156 West End Lane – West Hampstead

Stage 1 Road Safety Audit

Stage 1 Road Safety Audit

156 West End Lane, London - Planning Review

2.1 Location: Service / Vehicular Access, West End Lane

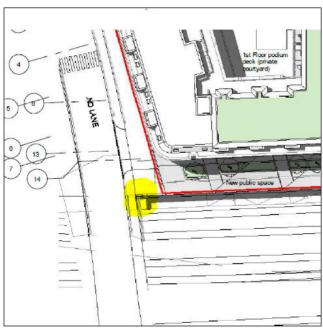
Problem Summary: The proposed access on the northern edge of the development requires exiting vehicles to cross the opposing side of the carriageway to exit.

The drawing 30760/AC/028 shows that a 10m and 10.7m articulated vehicle (both shown below) exiting the development and turning left is likely to come in to conflict with northbound vehicles. Given the vehicle flows (14,000 daily flow) this could lead to head on type accidents.

Recommendation: The Audit Team recommends that the access is amended so that exiting vehicles do not need to cross on to the opposing side of the carriageway to complete these manoeuvres.
